# Underwood Park

## Town of Belmont ADA Transition Plan

August 2021

Institute for Human Centered Design

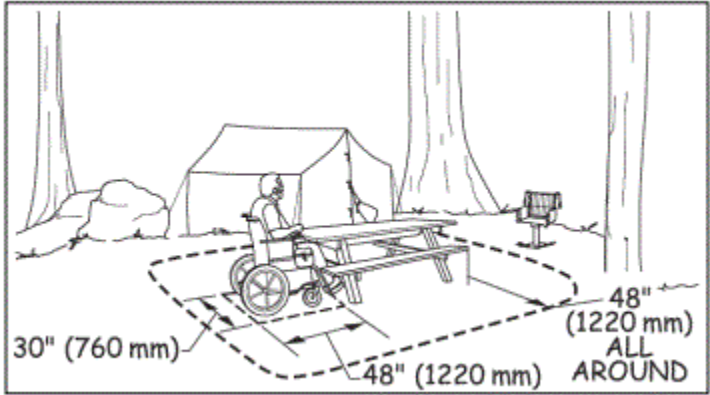
Accessibility issues include lack of an accessible route around the playgrounds with the swings and slides. There is also a lack of an impact attenuating accessible route to the play components inside the boundary of the playgrounds. See the following diagram depicting accessible routes around the playgrounds (in black) and to the play components in the playgrounds (in red). The route to the tetherball court is also shown:

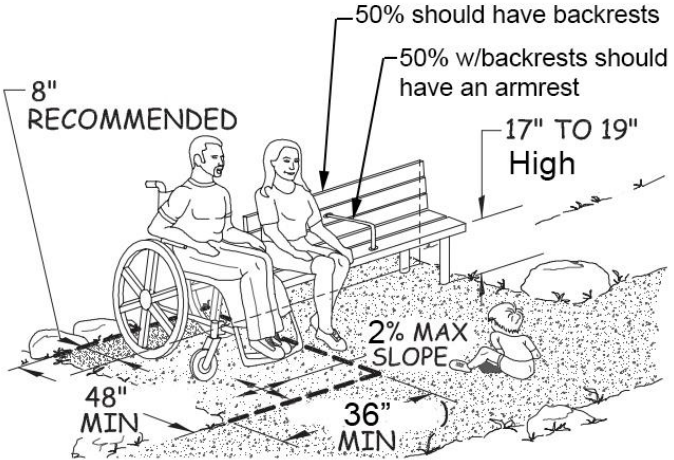
- IHCD strongly recommends exploring the possibility of an alternative surface to engineered wood fiber (EWF). Over time, EWF requires continuous maintenance to ensure the surface is maintained in operable working condition (stable, firm and slip-resistant). In addition, when used in combination with other surfaces required for accessible routes to play components in Massachusetts, it will present a challenge to prevent level changes at the transition points between EWF and other surfaces, and to keep the accessible routes clear of EWF.
- Recommend providing a 48" wide min. stable, firm and slip resistant surface under and around an accessible picnic table once it is placed in the picnic area and connected to an accessible route. See the following diagram:

- Recommend providing clear floor space of 36" wide minimum by 48" deep alongside one bench so that a wheelchair user can sit alongside someone sitting on the bench. See the following diagram:
